## HISTORIC AND DESIGN REVIEW COMMISSION

**HDRC CASE NO:** 2018-134  
**ADDRESS:** 1210 S ALAMO ST  
**LEGAL DESCRIPTION:** NCB 937 BLK 2 LOT N 100 FT OF 2, W TRI 5 FT OF 1 & S 8 FT OF N 100 FT OF 1  
**ZONING:** C-1,HS  
**CITY COUNCIL DIST.:** 1  
**DISTRICT:** King William Historic District  
**LANDMARK:** Kinchloe House  
**APPLICANT:** Richard Theis  
**OWNER:** RTJM, LLC  
**APPLICATION RECEIVED:** March 16, 2018  
**60-DAY REVIEW:** May 15, 2018  
**REQUEST:**

The applicant is requesting a Certificate of Appropriateness for approval to install a front yard wood picket fence featuring three (3) feet in height and a gate spanning across the driveway.

S. ALAMO ST

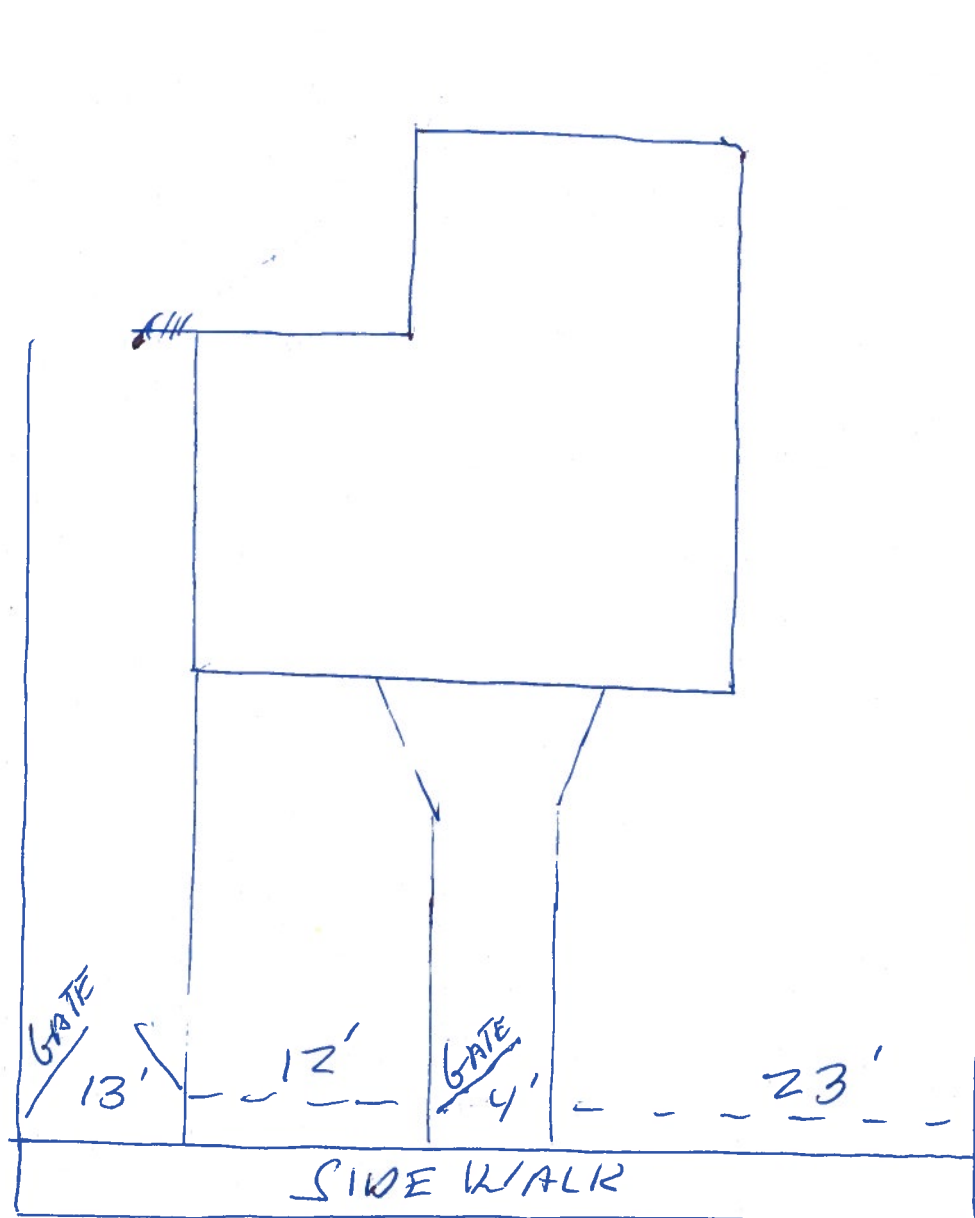
- b. FENCE LOCATION - The applicant has proposed to install a wood picket fence to span the width of the property, including a gate spanning across the driveway. According to the Guidelines for Site Elements 2.B.ii, new front yard fences should not be introduced within historic districts that did not historically have them. While staff finds that a fence was not currently present on this property, fences are found along S Alamo St and within the King William Historic District. Additionally, per the Guidelines for Site Elements 2.C.i., privacy fences, including the proposed driveway gate, should be set back from the front façade to reduce their visual prominence. Staff finds that the fence should turn at the driveway to meet the corner of the structure, rather than spanning across the driveway as proposed. Staff finds that the driveway gate, if included, should be set back behind the front façade plane of the structure.

- i. The fence turns at the driveway to meet at the corner of the structure, rather than spanning across the driveway as proposed.
- ii. The driveway gate be set behind the front façade plane of the structure or removed from the request.
- iii. No portions of the fence shall exceed four feet in height.
